# HISTORIC AND DESIGN REVIEW COMMISSION

**HDRC CASE NO:** 2024-392  
**ADDRESS:** 1510 E HOUSTON ST  
**LEGAL DESCRIPTION:** NCB 576 BLK 15A LOT E 31.1 FT OF 2  
**ZONING:** RM-4, H  
**CITY COUNCIL DIST.:** 2  
**DISTRICT:** Dignowity Hill Historic District  
**APPLICANT:** FELIPE DE JESUS  
**OWNER:** FELIPE DE JESUS/ALCALA FELIPE DE JESUS NAVARRO  
**TYPE OF WORK:** Construction of a 1-story, single-family residential structure  
**APPLICATION RECEIVED:** November 13, 2024  
**60-DAY REVIEW:** January 12, 2025  
**CASE MANAGER:** Edward Hall

The applicant is requesting a Certificate of Appropriateness for approval to construct a 1-story, single-family residential structure on the vacant lot at 1510 E Houston Street. This lot is located within the Dignowity Hill Historic District.

FLOOR PLAN  
SCALE: 1/4" = 1'-0"

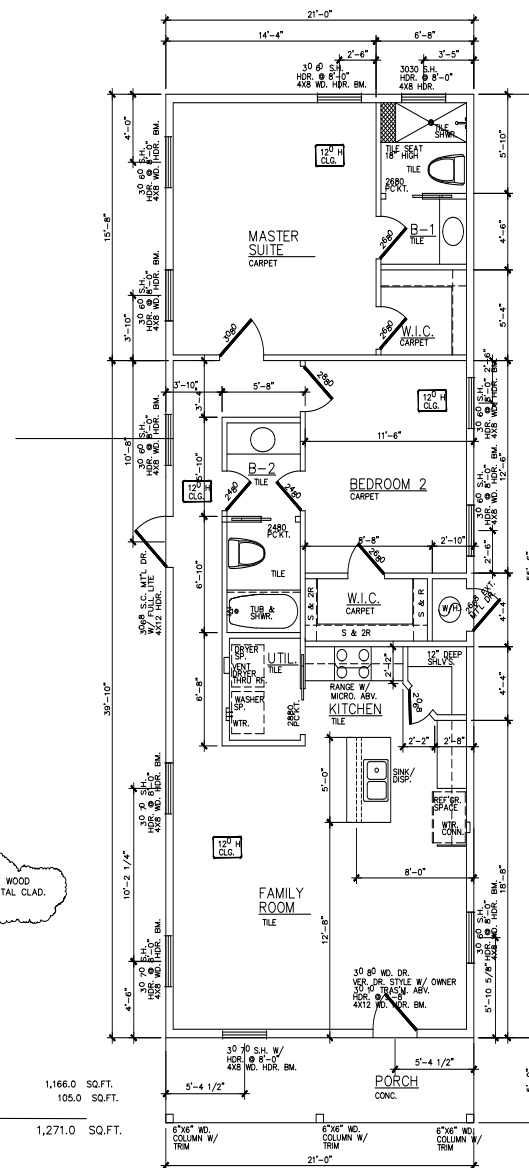
- a. LOT COVERAGE – The applicant has not provided a building to lot ratio. Per BCAD records, this lot features 2,944 square feet in size. Per the submitted site and floor plan, the applicant has proposed a footprint of 1,270.5 square feet. The Guidelines for New Construction 2.D.i. notes that new construction should be consistent with adjacent historic buildings in terms of the building to lot ratio. Footprints of new construction should be limited to no more than fifty (50) percent of the total lot area, unless adjacent historic buildings establish a precedent with a greater building to lot ratio. Staff finds the proposed footprint to be appropriate and consistent with the Guidelines.

FRONT ELEVATION  
SCALE: 1/4" = 1'-0"

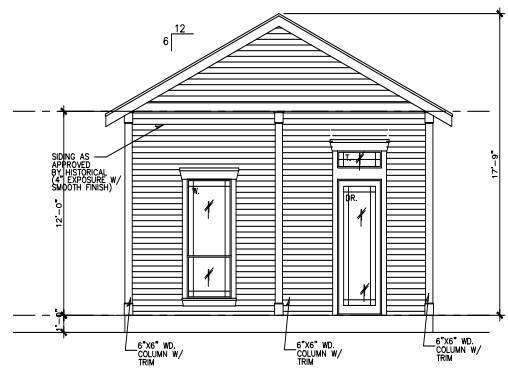
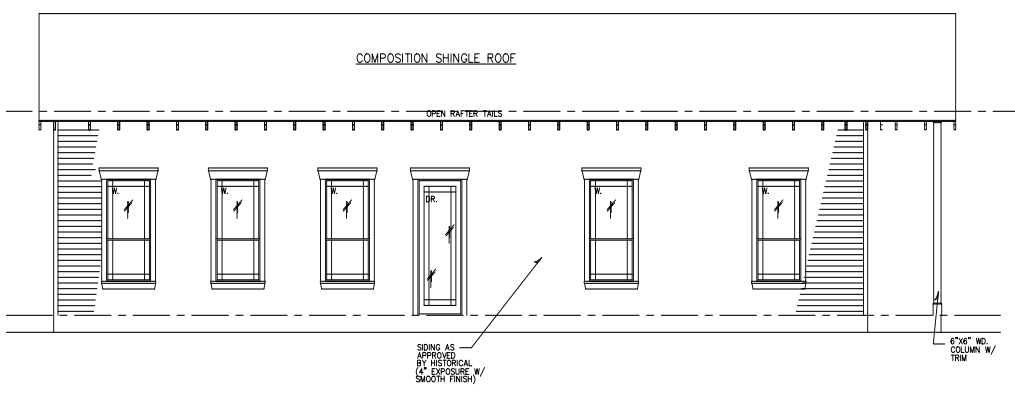
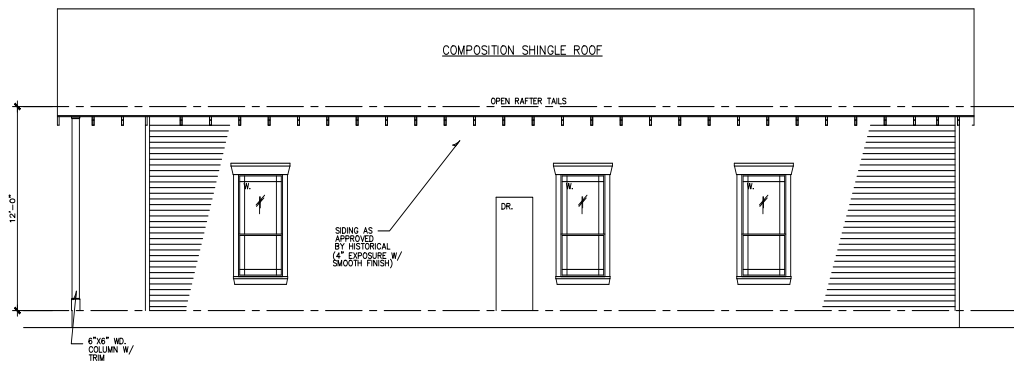
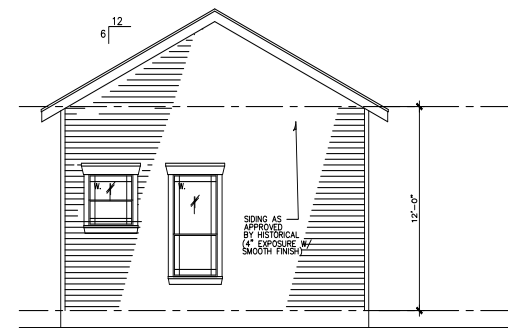
- vii. That wood or aluminum clad wood windows be installed, and that windows adhere to the adopted window standards. Windows should feature one over one profiles with equally sized sashes and no transom windows. Additionally, staff recommends that the proposed transom window above the front entrance roof be modified to relate to historically sized and proportioned transom windows. ***This stipulation has not been met.***

- ix. That columns that are six (6) inches square with capital and base trim be installed. If tapered, Craftsman style columns are proposed, a dimensioned column detail should be submitted for review and approval. ***This stipulation has not been met.***

- j. WINDOW MATERIALS – The applicant has not proposed window materials at this time; however, per the submitted construction documents the applicant has proposed window profiles that are atypical of the style and profile of windows found historically within the district. Staff finds that all window should feature one over one profiles with equally sized sashes. Additionally, staff finds that windows should adhere to the adopted standards for windows in new construction. These standards are noted in the applicable citations.

- m. ARCHITECTURAL DETAILS – Generally, staff finds the proposed architectural details to be appropriate and consistent with the Guidelines. As noted in finding j, staff finds that all windows should feature equally sized sashes.

- i. That wood or aluminum clad wood windows be installed, as noted in finding j and that windows adhere to the adopted window standards. Windows should feature one over one profiles with equally sized sashes.

- ii. That a dimensioned column detail be submitted for OHP staff review and approval.
- iii. That a detailed landscaping plan be submitted for OHP staff review and approval.
- iv. That the front walkway leading from the front porch to the sidewalk at the right of way feature concrete, as found consistently within the historic district.
